Town and Country Planning Act 1990

**St Wilfrid's Convent and Care Home, 29 Tite Street and Land to the West of the
National Army Museum, London, SW3 4JX**

Application reference: PP/25/04989

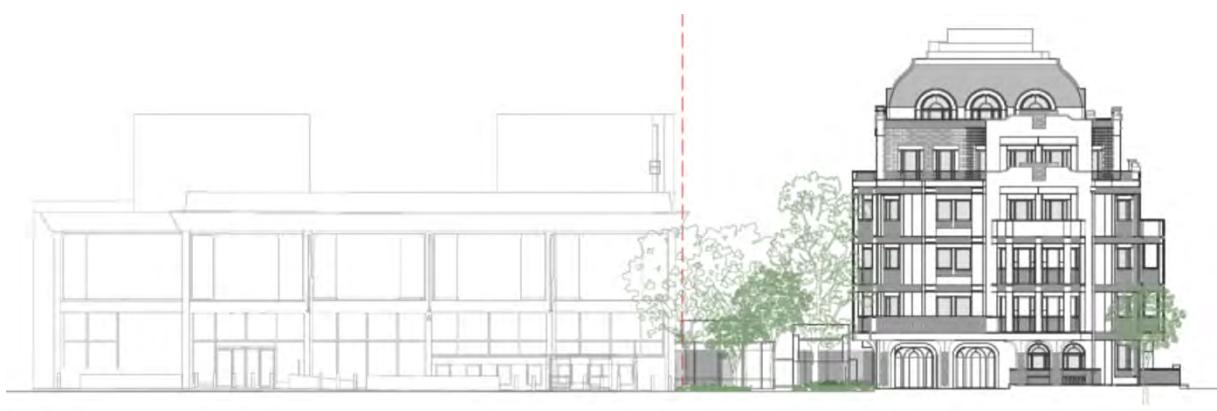
Scale and Massing & Townscape Gaps

Scale and Massing

14. Therefore, the height of the building should be reduced still further to below 21 metres with the height over the Tite Street gap/ garden where the Convent Chapel is no higher than the current height of the Chapel.

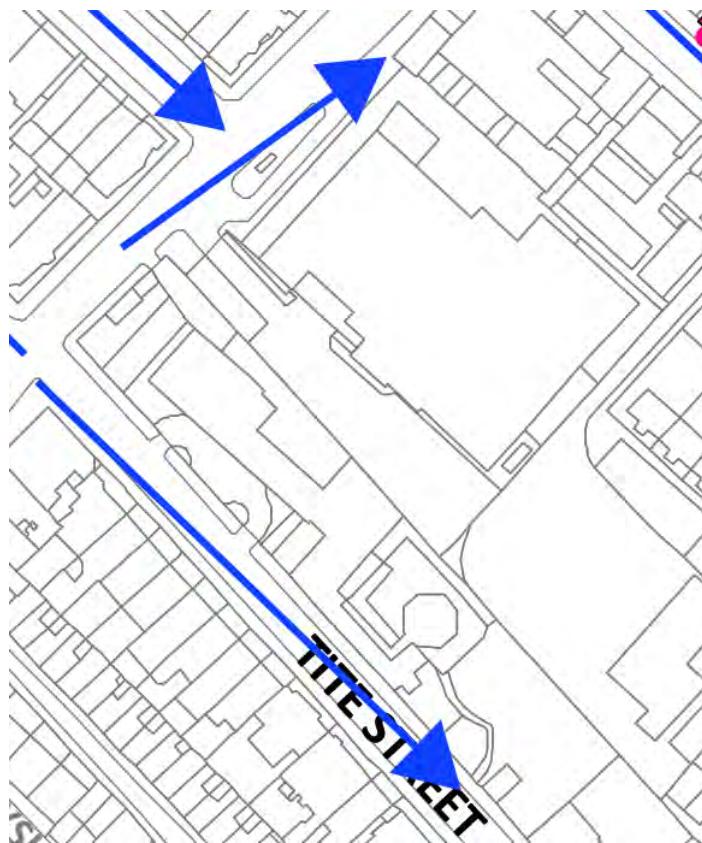
24. In respect of the Tite Street gap, the proposals would involve the encroachment of new build of up to 5 storeys (approximately 20 metres in height) over at least 50% of the existing Tite Street townscape gap. This would vitiate much of the benefit of the proposed green space (which in any case would be significantly smaller than the existing garden) and would significantly erode this gap to the detriment of the street and to the character and appearance of this part of the Conservation Area. This continues to remain incompatible with the Council's policy on gaps. Taken together with the very substantial increase in the scale, height and massing on the site proposed by the applicant, we consider that this would result in substantial harm to the Conservation Area and to its setting.

26. Paragraphs 3.10 and 3.11 of the Council's pre-application response of 24th February 2025 indicates a strong and justified resistance to the intrusion into the Tite Street gap to this extent. It notes that the existing Chapel is, effectively, single storey and thus a 5-storey structure over the whole of this part of the gap would be harmful to the Conservation Area and would also be harmful to the setting of Nos. 44 (Grade II*) and 46 (Grade II) Tite Street. The proposed building line to the Tite Street elevation where the building intrudes into the Tite Street gap would also continue to cause concern and would be harmful to the Conservation Area. As noted in the February 2025 advice at 3.10:

"As previously identified, it is recommended that development is pulled back to the established building line in line with the Chapel. The existing building line does intrude into important gap 1, which does establish a base line for development, albeit the built form in this location is primarily single storey. Development within the gap should therefore need to further reduce the overall height proposed where it intrudes into important gap 1. This should offer the opportunity to create an architecturally distinct building(s) to sit aside the main proposed mansion block. Such an alteration will also aid in addressing the grain of the proposed built form, being more responsive to the existing grain along Tite Street."
